# Technical Service Bulletin

<b>Topic</b>	HVAC failing to cool   DTC B16A1F0 in diagnostic address 00C5   Bentayga Series (Hybrid)   23MY - 25MY
<b>Market area</b>	Australia E04 Bentley rest Asia and Australia (6E04),China 723 Volkswagen (Anhui) Automotive CO (6723),China 796 VW Import Comp. Ltd (Vico), Beijing (6796),Germany E02 Bentley rest Europe (6E02),Japan E03 Bentley Japan (6E03),Korea, (South) E08 Bentley South Korea (6E08),United Arab Emirates E06 Bentley Middle East and Africa (6E06),United Kingdom E01 Bentley UK (6E01),United States E05 Bentley USA and rest America (6E05)
<b>Brand</b>	Bentley
<b>Transaction No.</b>	2071190/2
<b>Level</b>	EH
<b>Status</b>	Released for publishing
<b>Release date</b>	Apr 7, 2025

Figure 1

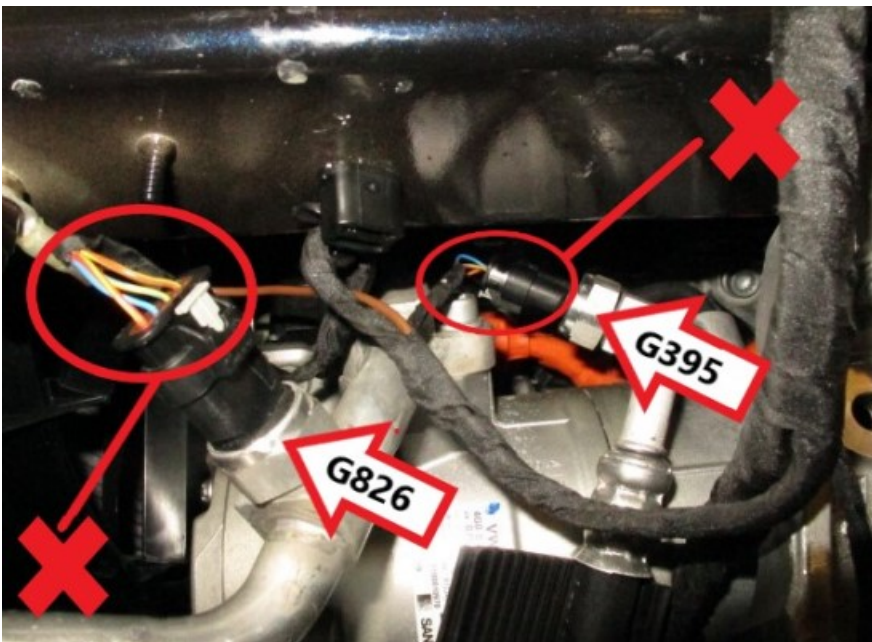
- 1) Referring to Rep.Gr 44 - Remove the left hand front wheel
- 2) Referring to Rep.Gr 66 - Remove the left hand front foremost wheel arch liner
- 3) Remove (x3) speaker box fixings (5Nm)
  - Disconnect the speaker box electrical connector
  - Remove the speaker box
- 4) Access can now be gained to the required connector plugs - Figure 1 shows G826 and G395 with the connector plugs fitted incorrectly
  - Low pressure sender G826 connector plug with 4 wires (**Incorrect**)
  - High pressure sender G395 connector plug with 3 wires (**Incorrect**)

In the event the pressure sender connector plugs are fitted incorrectly the plugs should be disconnected and refitted correctly as shown in Figures 2 and 3

Figure 2

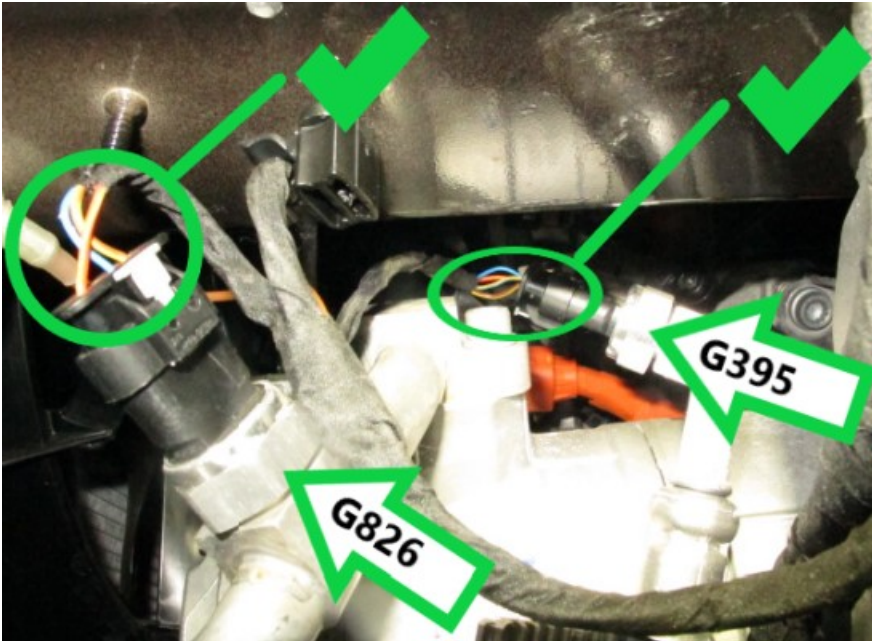
- Figure 2 shows G826 and G395 connector plugs fitted correctly
- Low pressure sender G826 connector plug with 3 wires (**Correct**)
- High pressure sender G395 connector plug with 4 wires (**Correct**)

Figure 3

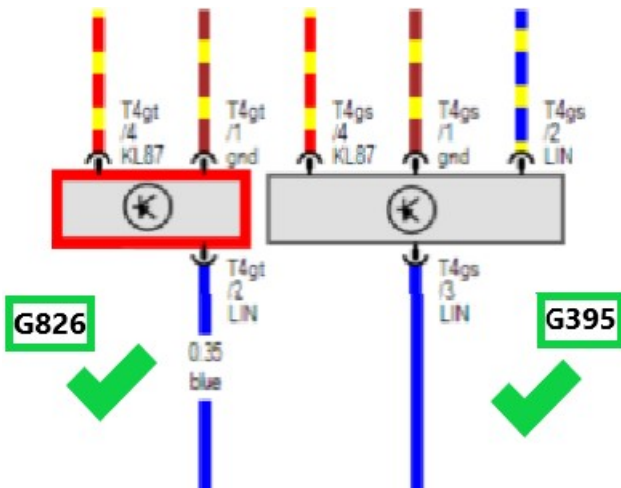
Hint: Figure 3 shows G826 and G395 as per the applicable Current Flow Diagram (Correct)
